Report-No.: Rp-2234-1030-0

## Summary of conceptual design for the ESTIA 'In-Bunker Beam Extraction System' to be build at ESS

Project/Projekt: P1030

The CDR review meeting took place at PSI on Oct. 9<sup>th</sup> from 12:30-14:30 with the following participants:

### 3.1 Design Concept

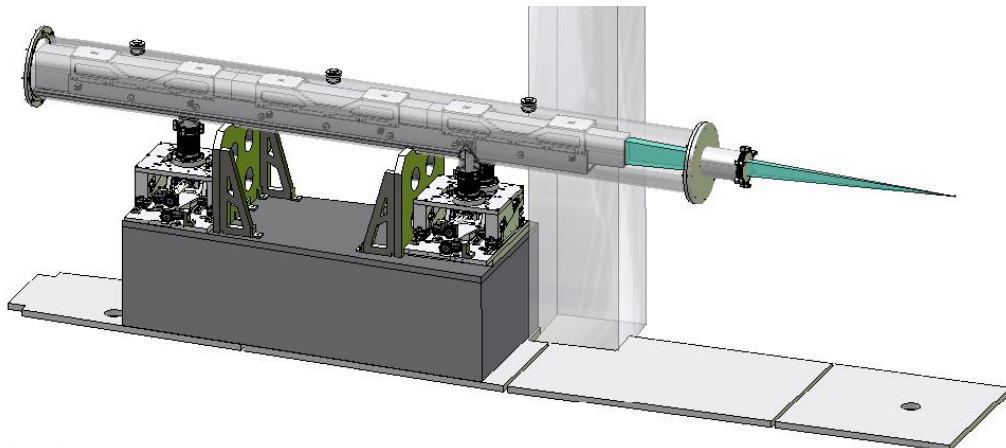
- Space constraints: Not all aspects of the given boundary conditions were fully clear up to now. One important aspect with regards to the insertion/removal of the whole unit to/from the bunker is the fact that the system can't be lifted straight upwards. An interfering installation upstream close to the bunker roof is obstructing the straight clearance, hence the device needs to be shifted downstream by approx.. 65.5mm
- A new (possible) requirement of design considerations had been mentioned early before and during the meeting but is not yet clear if and how it might have to be observed and covered. It seems that the design needs to demonstrate capabilities of 2g accelerations in case of earthquakes. The design has not covered such aspects up to know and it needs to be clearly communicated in case it has to.

- Materials is an ongoing point where specifications and final usability is not fully defined yet. There is a list of allowed materials (refer to [6], latest version supplied on Oct. 2<sup>nd</sup> 2017) which we try to observe and to follow. Additionally during the meeting the complex of problems regarding lubrication came up. This aspect has not been covered yet and may affect the design of the linear stage (slides and bearings).

- Within this subject, it was discussed and agreed to skip the up to know foreseen EPDM seal at the entrance flange and replace it with a full metal solution. Reference was given with an example presented at the last ICON meeting at the ESS ([7]). For the aluminium wire seal a reference from Goodfellow was mentioned during the meeting

- Thickness of entrance window: the thickness should be as small as possible regarding neutron absorption and scattering but as thick as possible from the point of safety. Up to now we have foreseen to realize a thickness of 0.5mm, this has to be analysed and verified with FEA in the ongoing design process. From the operational point of view it would be necessary to define clear requirements from acceptable absorption and stringent safety regulation. It is expected that this window falls under the rule of ESS (i.e. "a thin window is what bends more than its thickness").

- The chamber shall comprise additional flanges for pumping and vacuum monitoring. It was agreed to add one ISO-KF DN40 flanges for monitoring and one ISO-K DN60 for pumping. Flanges will be located close to the downstream chamber end, pointing upwards

- o maintain the current assumption of 15mm guide wall thickness, whereas the realisation will most likely be a 8-9mm thick aluminium guide and a 6mm thick MirroBor shielding compound around it

- o use three segments, each 1093mm long resulting in a total guide of 3280mm length (with 0.5mm gap between the segments)
  - o each segment will rest on 4 points located along the segments in the corresponding Bessel points. The distance of the two points on each end will be such that each contact point is central to a vertical wall. No 'bridge' underneath the guide needed, no forces on guide walls.

- o for locking the position of each segment spring loaded ball tips will be positioned on the top of each segment, directly above the four support points as well as four contacts at the sides, acting on the height of the bottom part of each guide segment (two fix ball contacts on one side, two spring loaded pushing against on the other side)

- o the segments will be made from aluminium, for designing and predicting the gravitational sag of the carrier one should assume the guides to be made from copper.
